DWR EXHIBIT K Application, File No. 45,576

APPLICATION FOR PERMIT TO APPROPRIATE WATER FOR BENEFICIAL USE

Re: Application No. 45576 - City of Wichita

The referenced application was reviewed by the Equus Beds Groundwater Management District pursuant to K.A.R. 5-22-12. The application was reviewed using the District's Revised Management Program (effective May 1, 1995), and Rules and Regulations K.A.R. 5-22-1 through 5-22-12. Copies of the District's Application Review Information report and the independent consultant's project report are enclosed for your information.

Figure 1. - Equus Beds Groundwater Management District No. 2 Aquifer Storage and Recovery Project Map July 13, 2004

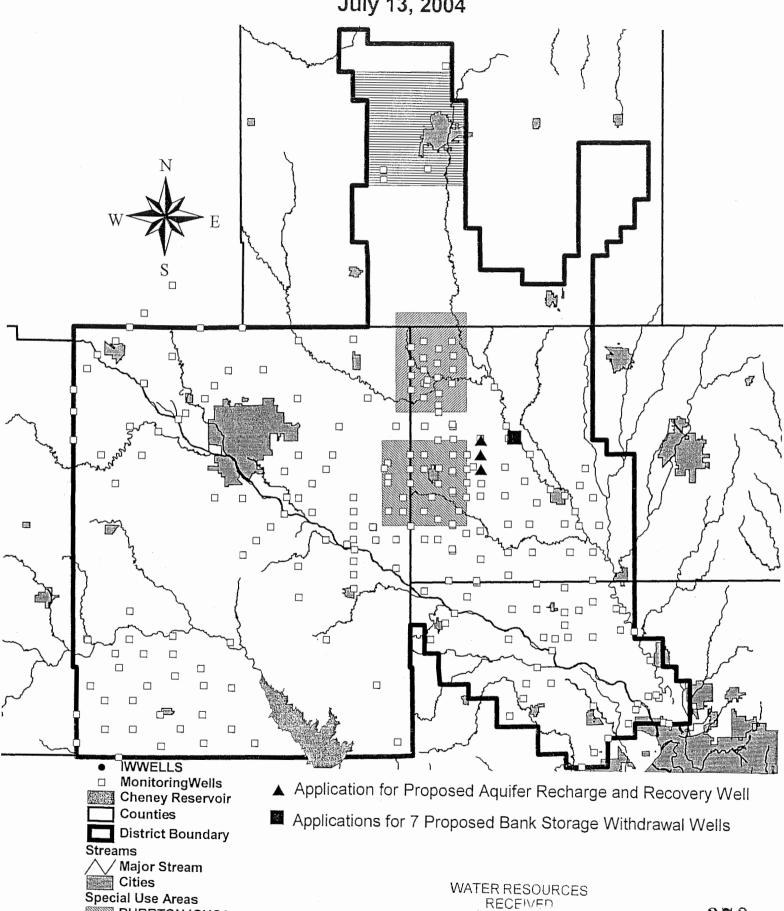
The applicant's proposal for aquifer storage will consist of a basin storage area underlying an area approximately 92,720 acres in size (figure 3). The following Division of Water Resources regulations as defined by K.A.R. 5-5-1, shall apply to the ASR project:

Based on Kansas Geological Survey methodology for optimum monitoring well network design, the basin storage area was sub-divided into of 38 water budget accounting units, each comprised of a four square mile area (figure 3). Each unit consists of a monitoring well site utilized to obtain index water levels, and water quality data.

- as determined by Kansas Geological Survey methodology the basin storage area is divided into 38 water budget accounting units and each unit is assigned an index identification number as shown on figure 3;

Figure 9. –
Application
No. 45576
Example of
Construction
Design for
Recharge and
Recovery Well

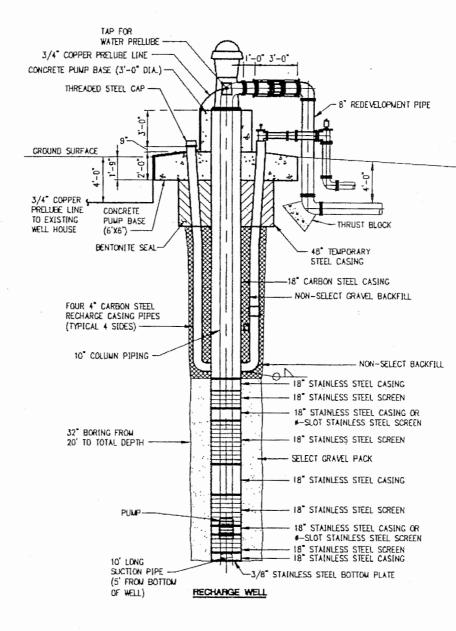
The application's proposed well depth is 124 feet bls to be completed in the lower portion of the aquifer. Proposed well construction specifications were not submitted with the application. An example diagram of recharge and recovery well construction was included in the applicant's demonstration project report (figure 9).

- 19) before installation of the proposed ASR well, the applicant shall submit a water level and water quality monitoring plan to GMD2 for review and comment and to the Chief Engineer, DWR for approval:
